**COMMENTS OF CITIZENS ACTION COALITION OF INDIANA, INC.,
EARTHJUSTICE, MULLETT & ASSOCIATES AND SIERRA CLUB ON THE IURC
ELECTRICITY DIVISION DIRECTOR'S DRAFT REPORT REGARDING 2013
INTEGRATED RESOURCE PLANS**

Figure 1: DEI's incremental energy efficiency savings, by year.

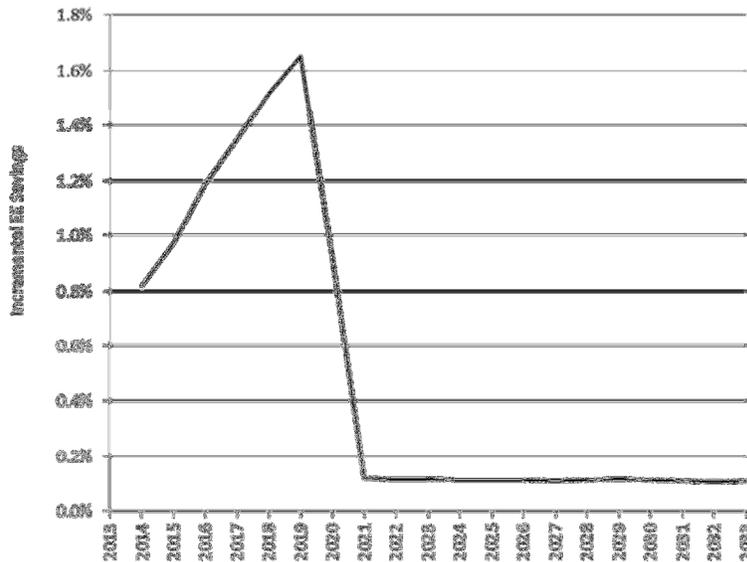
In its reference scenario, DEI assumed that it will comply with the then-existing energy savings goal by 2019 – a commitment that Commenters hope DEI will continue to meet, even with the enactment of SEA 340 – but then will effectively stop saving energy. As Figure 1 below shows, DEI projected that efficiency savings drop to a mere 0.1% per year after 2020, or about one sixteenth the rate it achieved in 2019.

Modeled this way, DEI essentially dropped energy efficiency out of its long-term plan to meet the resource needs of its customers. The result is a plan that must rely on more expensive supply-side generation to meet energy demand. As discussed in our comments on DEI's IRP, a conservative assumption of 1% incremental savings after 2019 would result in a significant decrease in peak load throughout the modeling period. (CAC et al.'s Duke Comments at 18-19.) Specifically, a 1% savings scenario after 2019 would result in an additional 733 MW in load reduction by the end of the planning period, as shown in Figure 2 below. Put differently, with a

Figure 2. Peak load forecast for DEI, with DEI assumed EE, and Peak load savings at 1% incremental past 2019.

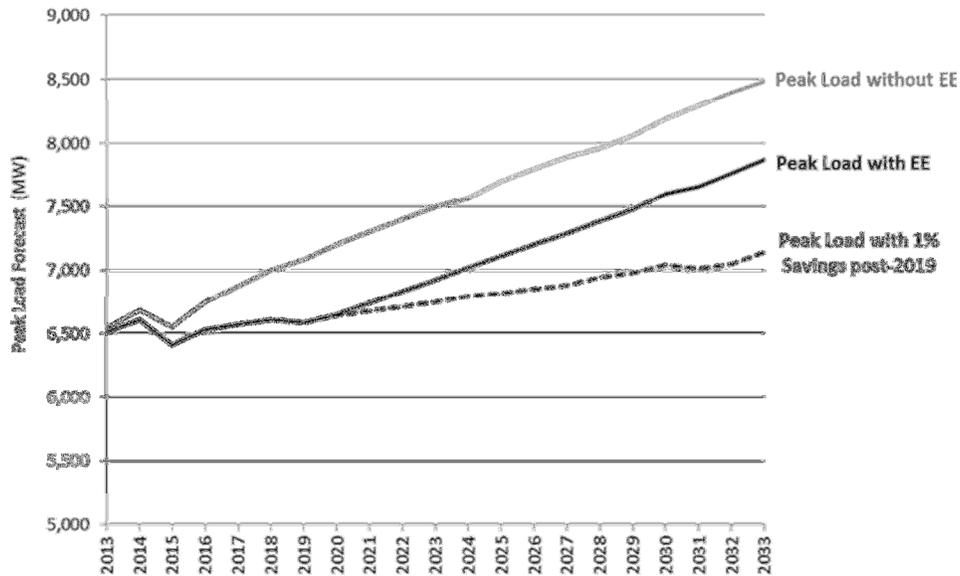
more reasonable energy efficiency assumption, DEI could save the rough equivalent of a new natural gas combined-cycle plant.

As detailed in our comments and reflected in the Draft Report, DEI's approach to modeling energy efficiency resources is flawed. Rather than letting efficiency compete with supply-side resources through an optimization process, the Company fixed an insufficient level of efficiency in its model. This substantial methodological flaw, in addition to the questions raised in the Draft Report concerning the incorporation of efficiency load impacts, should be reflected in the Commission's final report and addressed by the Company.
